8-C-25-HZ
APPLICATION FOR CERTIFICATE OF APPROPRIATENESS

1428 Fremont Place 37917
Old North Knoxville H

Original Print Date: 8/6/2025
 Knoxville/Knox County Planning -- Historic Zoning Commission

Location: 1428 Fremont Place **Parcel ID** 81 L F 001
District: Old North Knoxville H
Zoning: RN-2 (Single-Family Residential Neighborhood)
Description: Craftsman Bungalow, c. 1926.

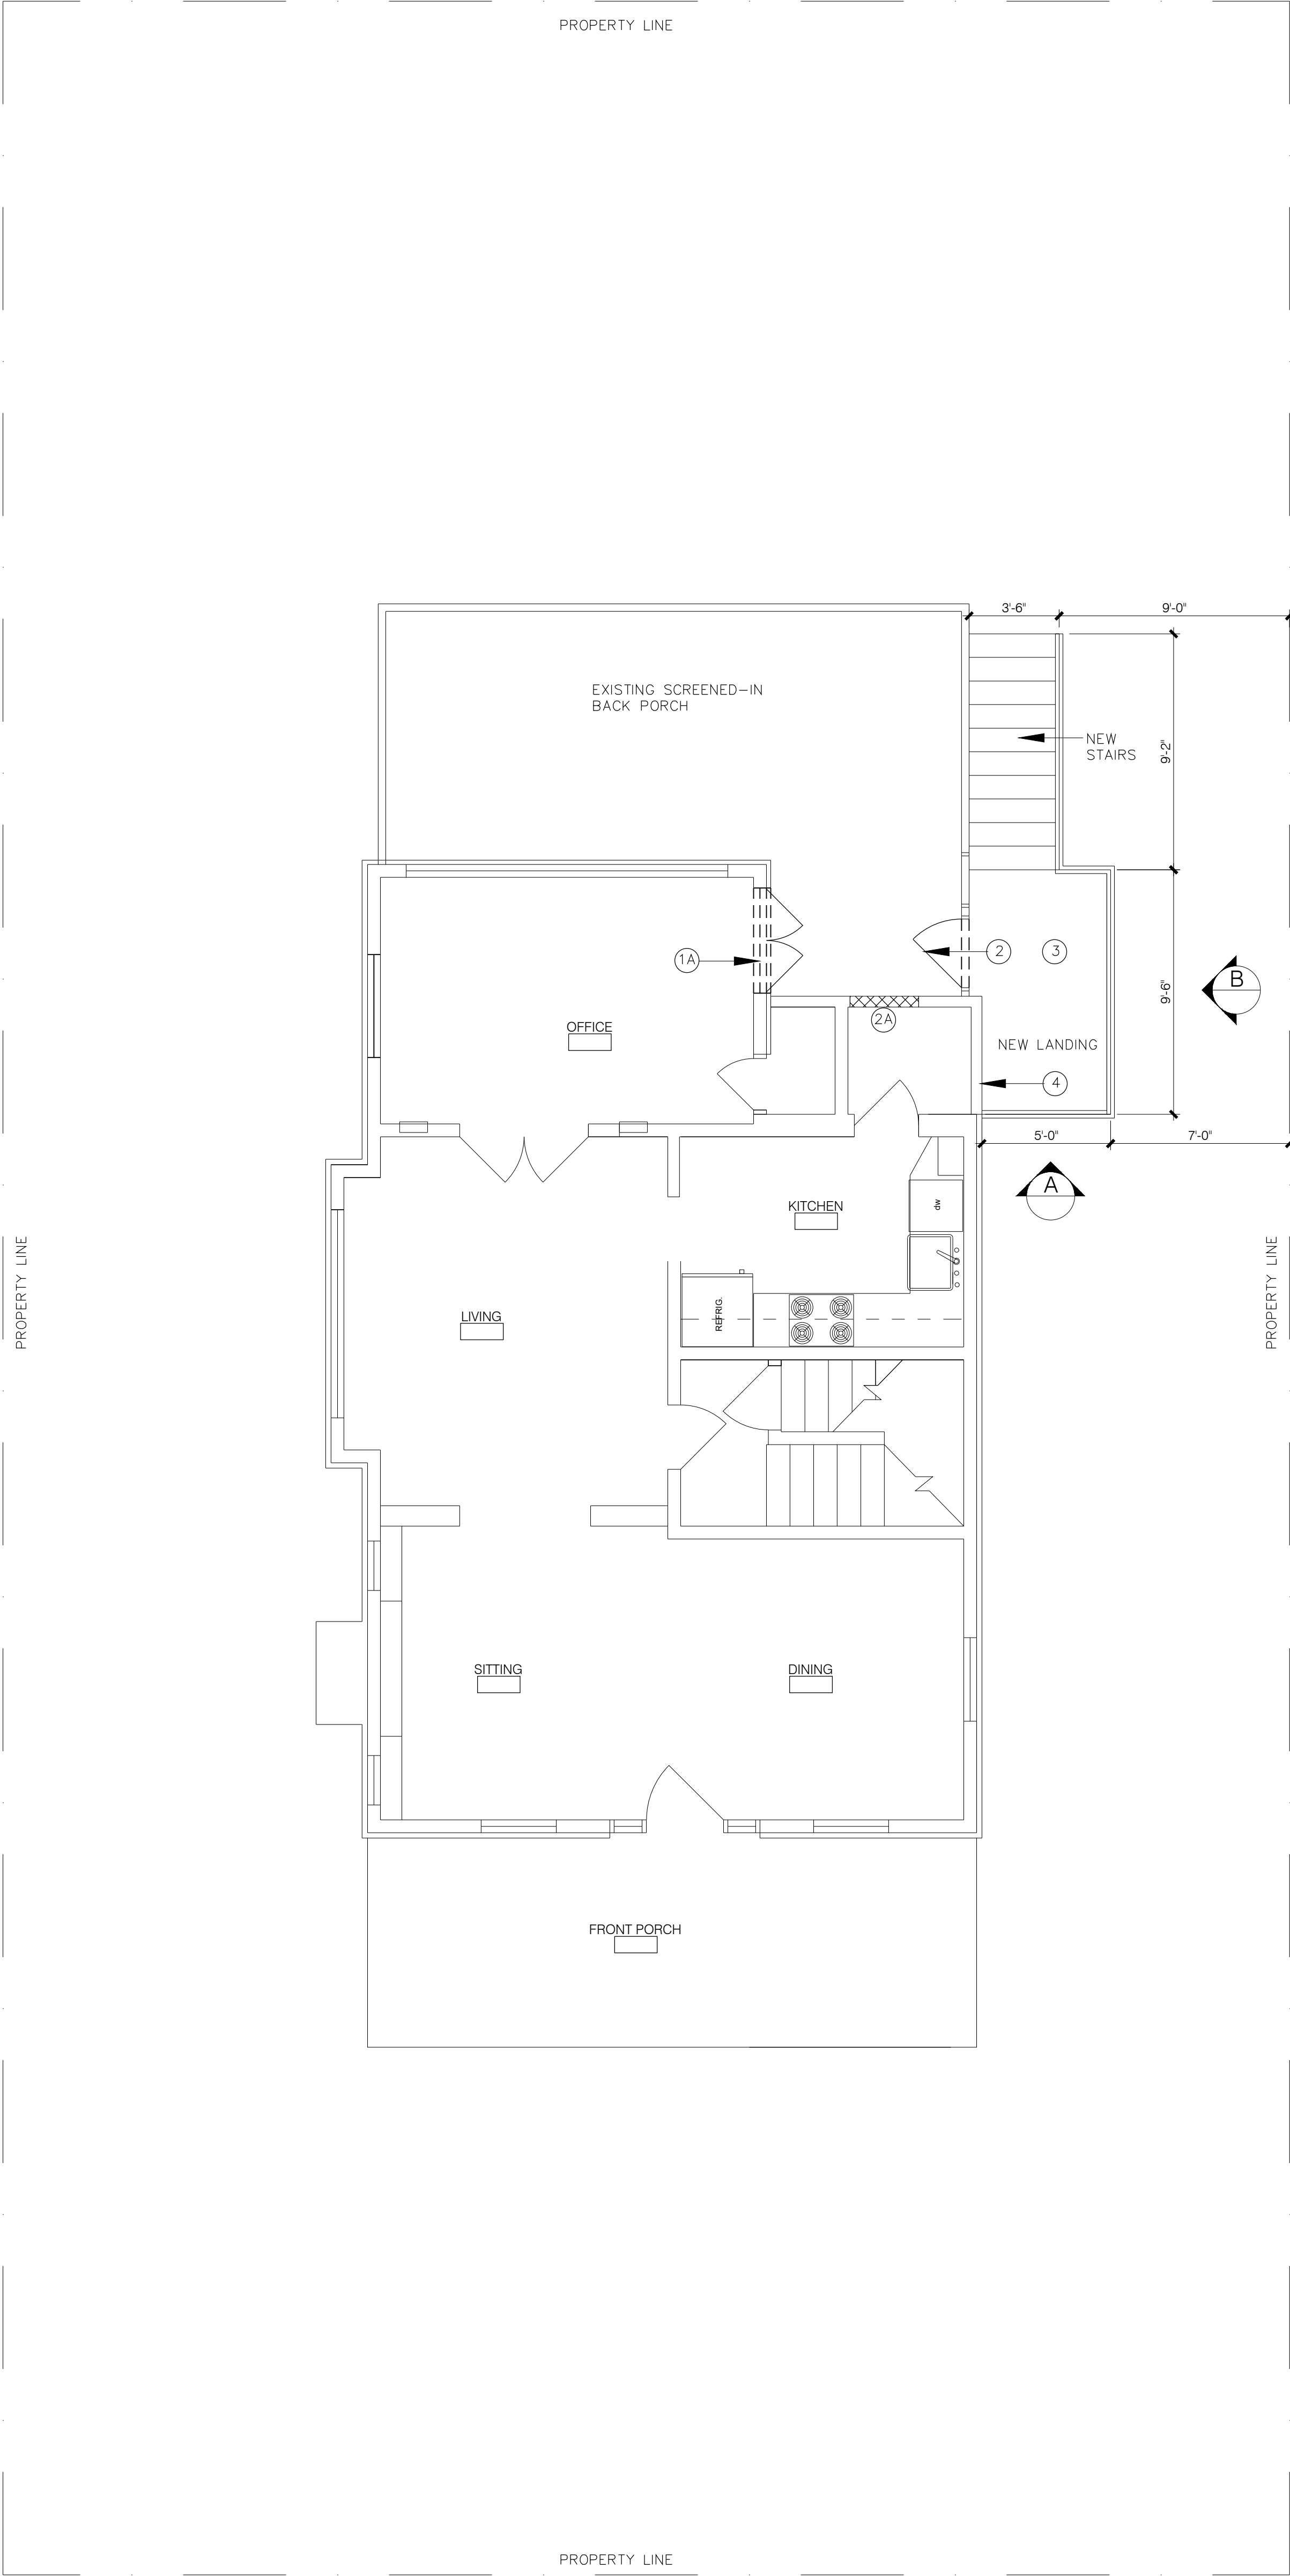
2. Although design guidelines discourage closing original window openings, the removal of an original window to install a new secondary entrance has been approved if it is minimally visible from the street. The property is on a corner lot, but the rear of the house is obscured by trees and the screened in porch, making it minimally visible. Removal of the casement window is appropriate.

3. Although design guidelines discourage removing original entrances and entry features, removal of secondary entrances has been approved on rear elevations. The existing door should be retained for re-use, if at all possible. Removing the entrance and enclosing it with in-kind wood lap siding is appropriate.

4. The proposed 12-lite wood French doors and wood transom window to be installed feature a similar design to the historic casement window that they will replace, and they are compatible in material and design with the house. While guidelines discourage adding transom windows to secondary entrances, the existing secondary entrance they are proposing to remove features a transom window, and the French doors will not be mistaken as a formal entrance. Grids between the glass are typically not compatible with historic window patterns, as they lack the dimension and depth of exterior muntins, so the doors should feature simulated divided lights; final selections should be sent to staff for review

Staff recommends approval of Certificate 8-C-25-HZ, subject to one condition: 1) final door selection be sent to staff for review.
